Salem Generating Station, Units 1 and 2

S-C-SF-MEE-1679, Rev. 1

SFP Cooling System Capability With Core Offload Starting 85-hours After Shutdown

COMMENT / RESOLUTION FORM FOR DESIGN DOCUMENT

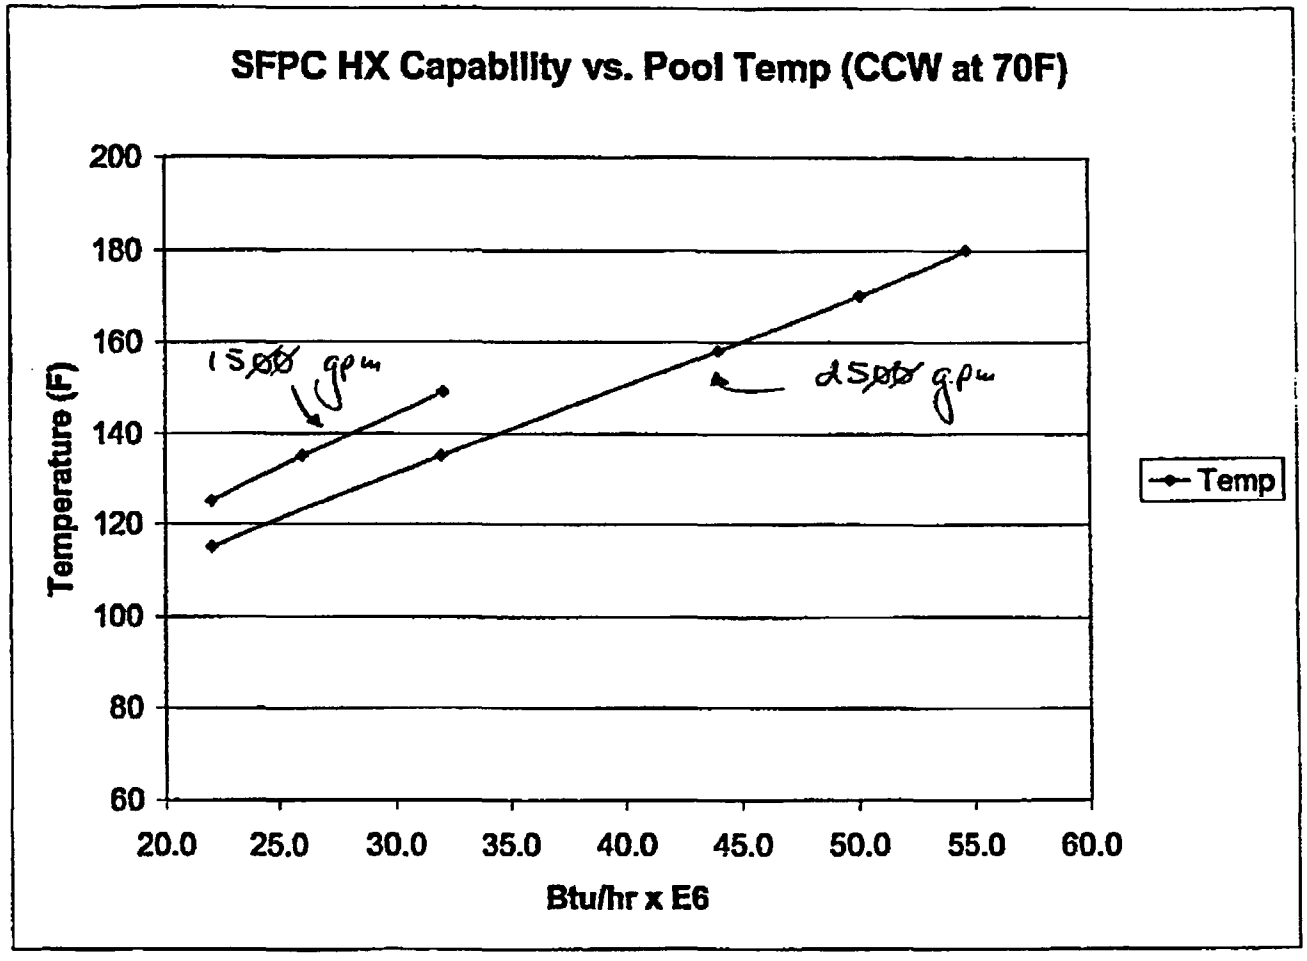
10) Make note on Attachment D, graph is for SFP only.
11) Section 3.5, change words "only" and "exclusively" per markup since we do credit evaporation for the limiting case.

10. The note has been added to Attachment D
11. Done
12. Done
13. Footnote #2 now refers back to footnote #1.
14. This has been corrected. I had used the enthalpy of saturated steam at 180F when I should have used the latent heat of vaporization. The numbers have been revised accordingly, including the make up rate.
